Sewerage & Water Board of NEW ORLEANS

Addendum No. 2

Your reference is directed to **Contract 1443 – WEST POWER COMPLEX @ CWTP - CLAIBORNE WATER SUPPLY TIE-IN** for the Sewerage and Water Board of New Orleans which is scheduled to open at **11:30 a.m.** **Local time on May 10, 2024.**

Questions and Responses During Bidding

PIPE SUPPORT DETAIL 2

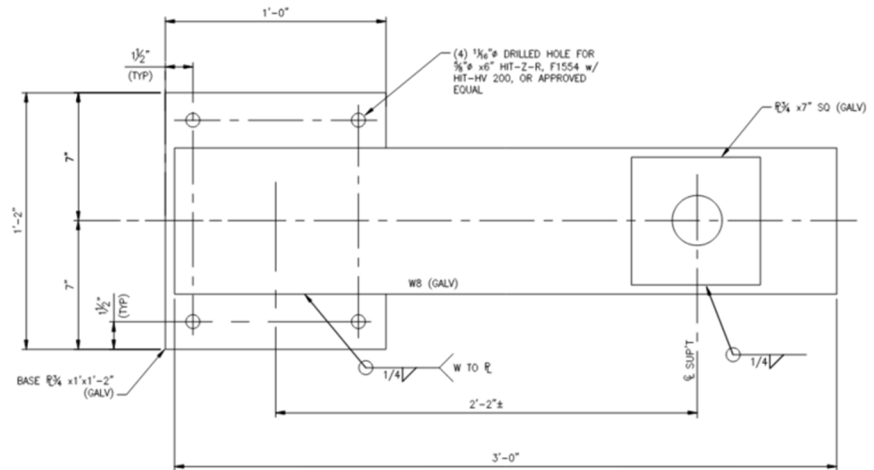
RESPONSE #1	Per note on drawing M2.05, "Existing ramps, sidewalk, and handrail disturbed during construction shall be repaired in kind. See Vol 4 Reference Drawings, Contract 1403, Sheet 23." Sidewalk or other existing items removed and replaced during the directional drilling efforts shall be included in Directionally Drill 12" PVC Pipe. Payment Item Description will be updated in the Conformed Contract documents to include removal and replacement of sidewalk, ramps, and handrail as necessary.
BIDDER QUESTION #2	On Sheet M2.02, the plans calls for "Pipe Supports, Detail 2 on Sht M4.02", this design will cause issues with the existing handrails. Please advise!

RESPONSE #2	Pipe Support Detail 2 and Section B on M4.02 shall be replaced with the following. Drawing M4.02 will be revised and reissued as part of the Conformed Contract set of drawings.
